City of Kirkland
Reviewed By J Goucher
11/25/2023

REMODEL
GIAN
209

733 LAKE STREET S, APT 209
KIRKLAND, WA 98033

PERMIT SET

2 SITE PLAN
SCALE: 1" = 30'-0"

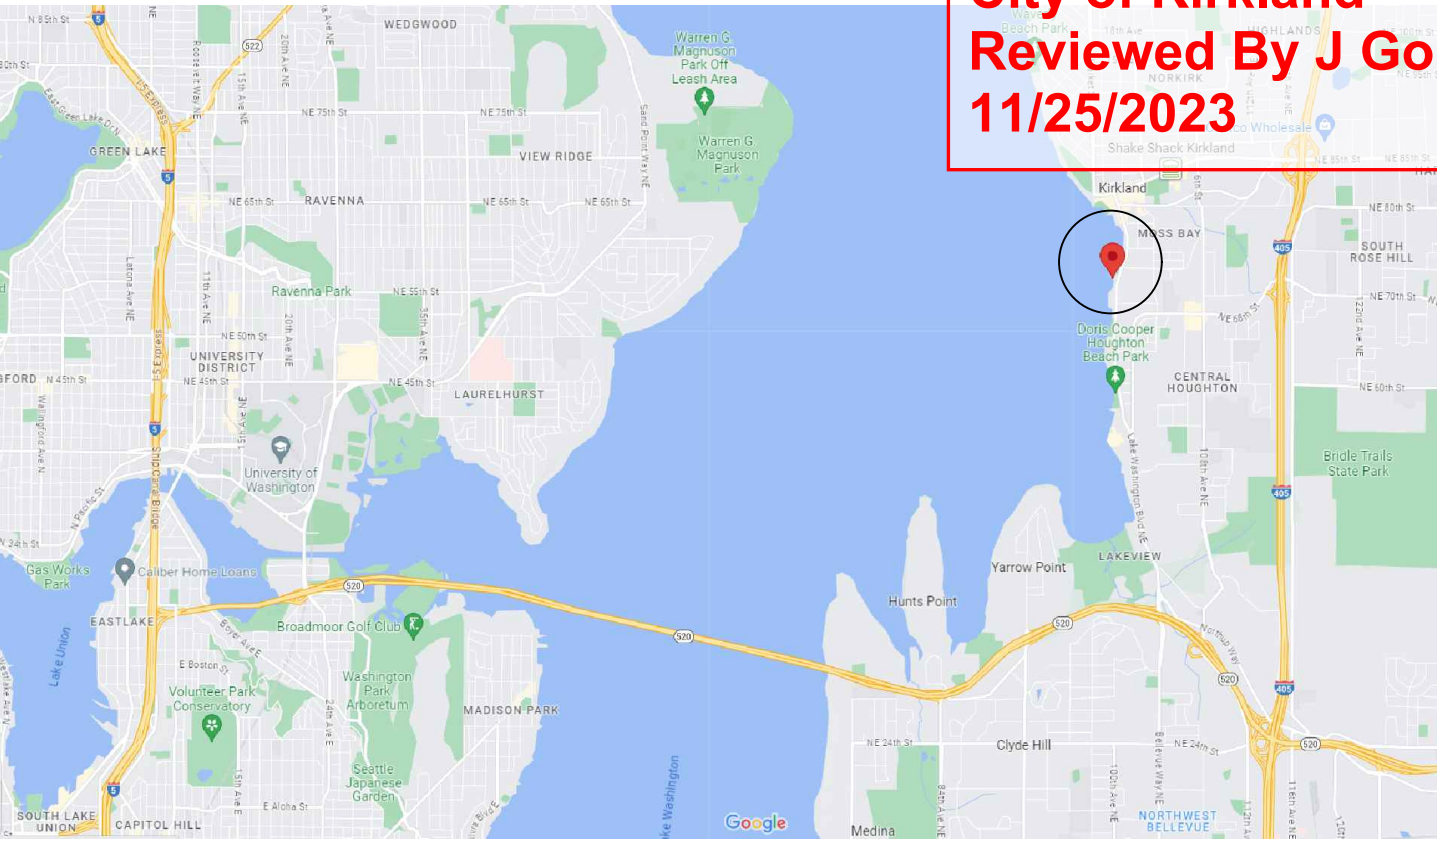
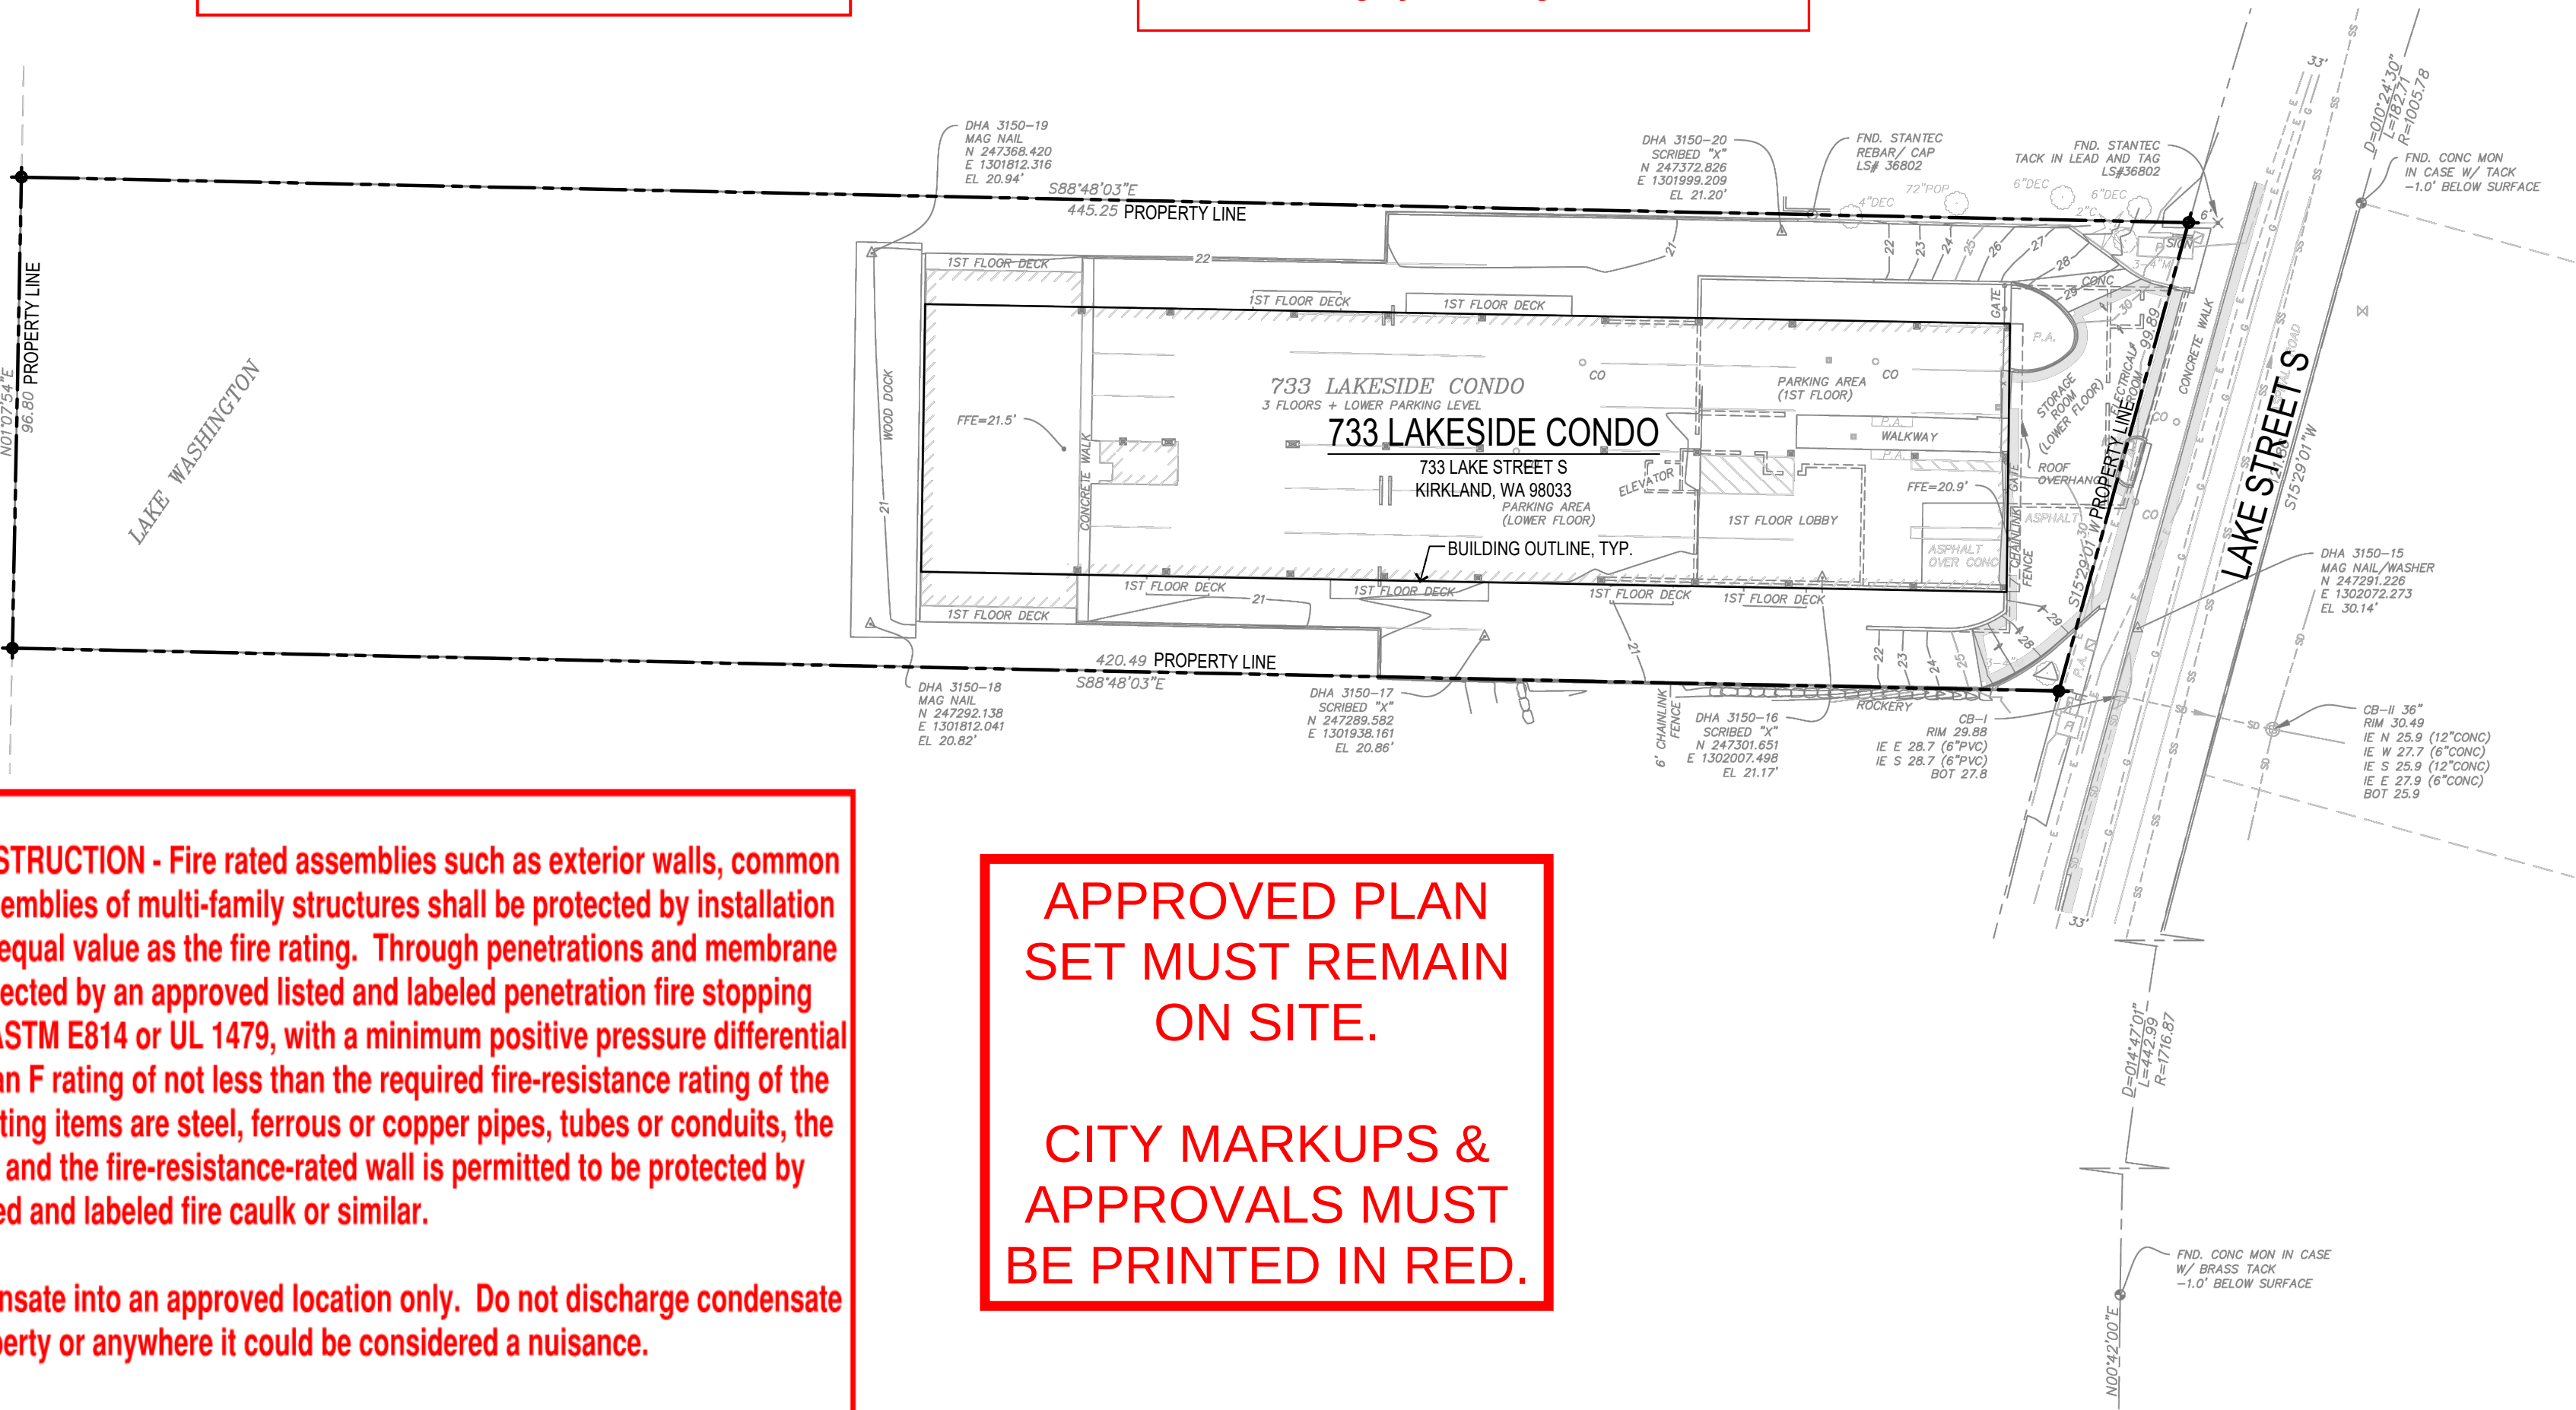
EXPOSED WALL CAVITIES
MUST BE INSULATED-
2X4 WALL STUDS REQUIRED
R-15 INSULATION
2X6 WALL STUDS REQUIRE
R-21 INSULATION

WALK IN SHOWER RECEPTORS
MUST COMPLY WITH STATE
AMENDED 2018 UPC 408.5 -408.7

PENETRATIONS THROUGH FIRE RATED CONSTRUCTION - Fire rated assemblies such as exterior walls, common
walls, floor ceiling assemblies, and ceiling assemblies of multi-family structures shall be protected by installation
of a listed and labeled fire stopping system of equal value as the fire rating. Through penetrations and membrane
(1 side of the wall) penetrations shall be protected by an approved listed and labeled penetration fire stopping
system installed as tested in accordance with ASTM E814 or UL 1479, with a minimum positive pressure differential
of 0.01 inch (2.49 Pa) of water and shall have an F rating of not less than the required fire-resistance rating of the
wall penetrated. Exception: Where the penetrating items are steel, ferrous or copper pipes, tubes or conduits, the
annular space between the penetrating item and the fire-resistance-rated wall is permitted to be protected by
approved listed and labeled fire caulk or similar.

CONDENSATE DISCHARGE - Discharge condensate into an approved location only. Do not discharge condensate
on a sidewalk, neighboring property or anywhere it could be considered a nuisance.

Smoke alarms are required in each
sleeping room, outside each separate
sleeping area in the immediate vicinity
of the bedrooms and at each story and
shall be interconnected per Washington
State Amendments IRC R314.

Carbon monoxide alarms are required
outside of each sleeping area in the
immediate vicinity of the bedrooms and
on each level. Washington State
Amendments IRC 315.1
